GEORGE MASON MEMORIAL, FOUNTAIN FOUR
West Potomac Park East of Inlet Bridge over the Tidal Basin

Report to the National Park Service

May 4, 2000

THE GEORGE MASON MEMORIAL GARDEN
Design Development Site Plan

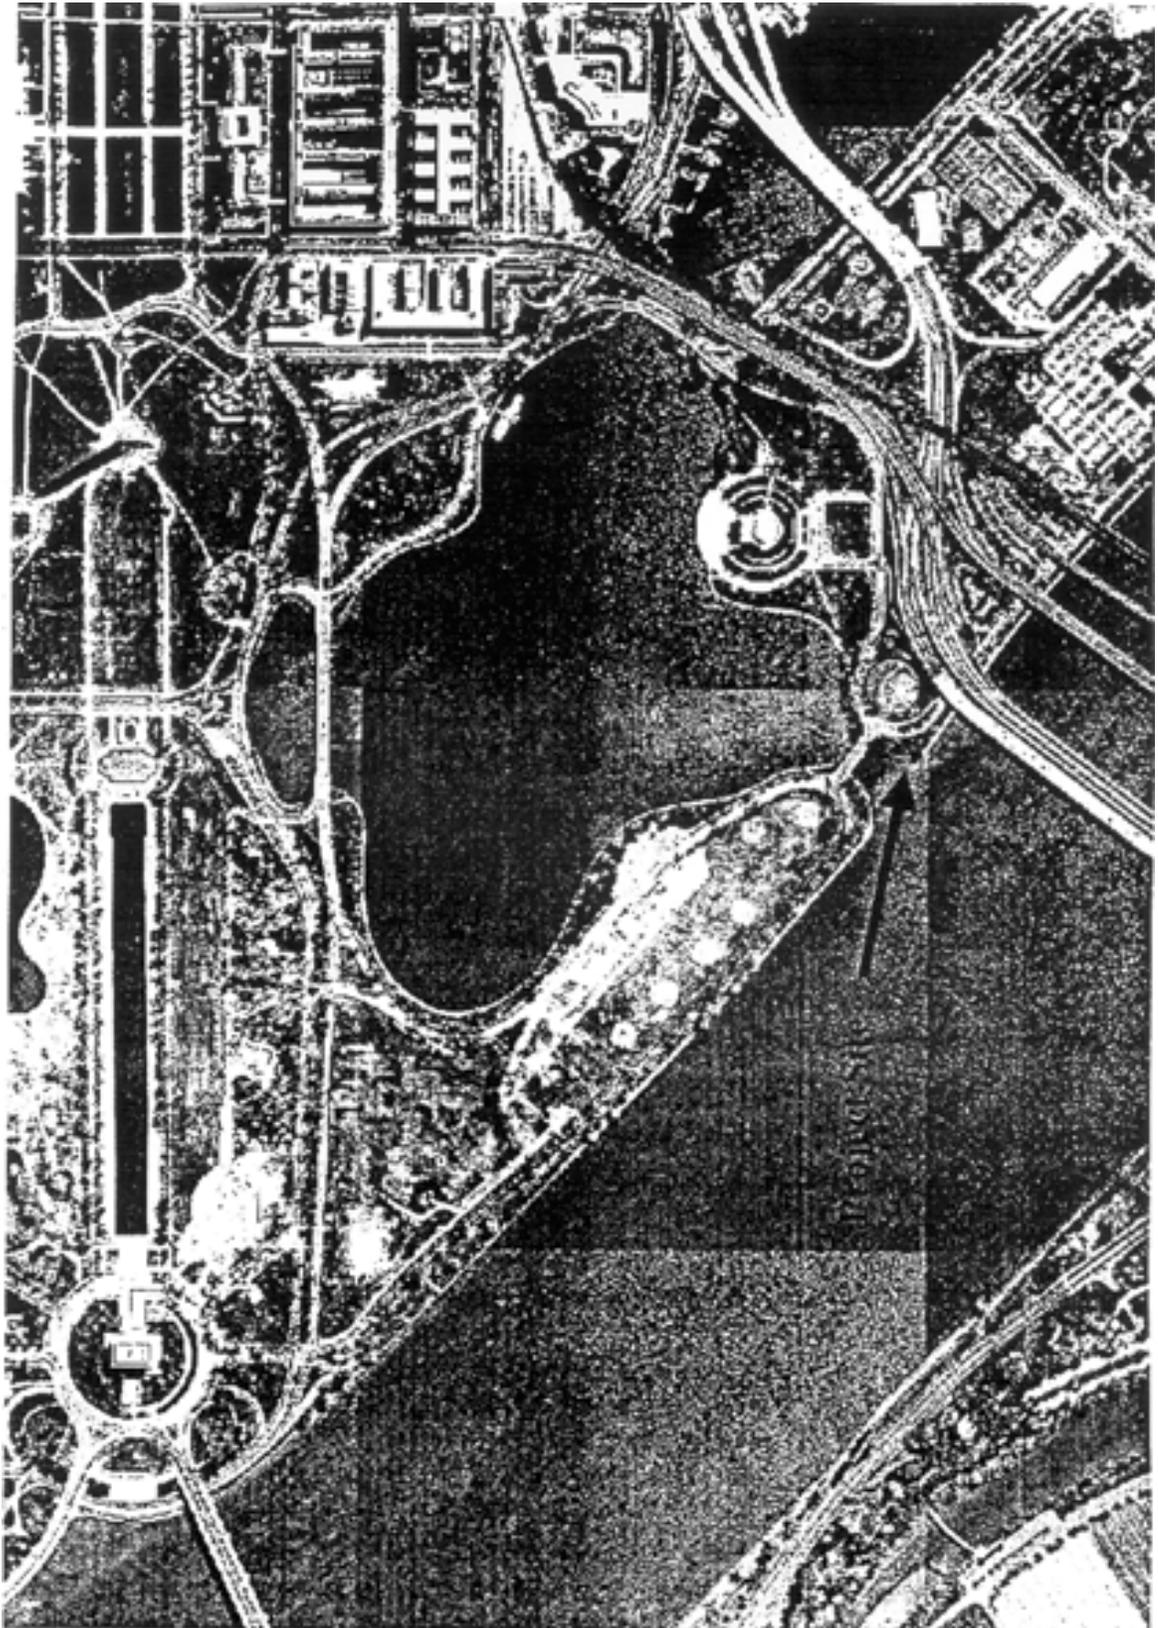
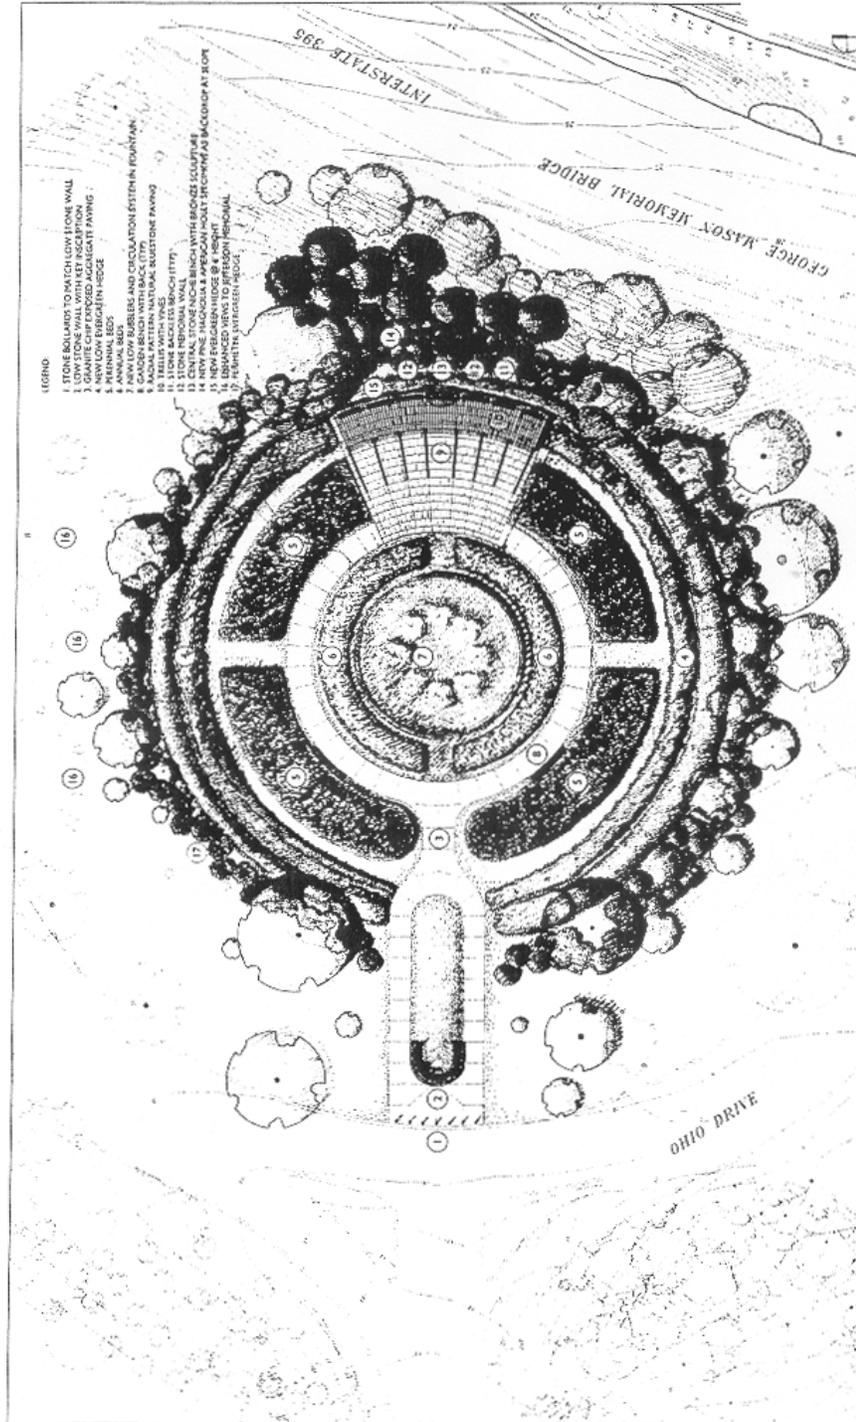
Previously, at the design concept stage of review, the staff felt that the relationship between the sculptural element and the trellis could be refined to give more prominence to the sculptural element. The current plans increase the height of the portion of trellis that is directly above the sculptural element to provide more emphasis. Staff concurs with this solution and feels that,

given the location of the sculptural element and bench on axis within the garden and the increased height of the trellis, the sculptural element is given more prominence.

Although the Park Service requested both preliminary and final approval, staff recommends that only preliminary approval be given at this time because the project submission does not include sufficiently detailed plans of the trellis structure and the sculpture to warrant final approval.
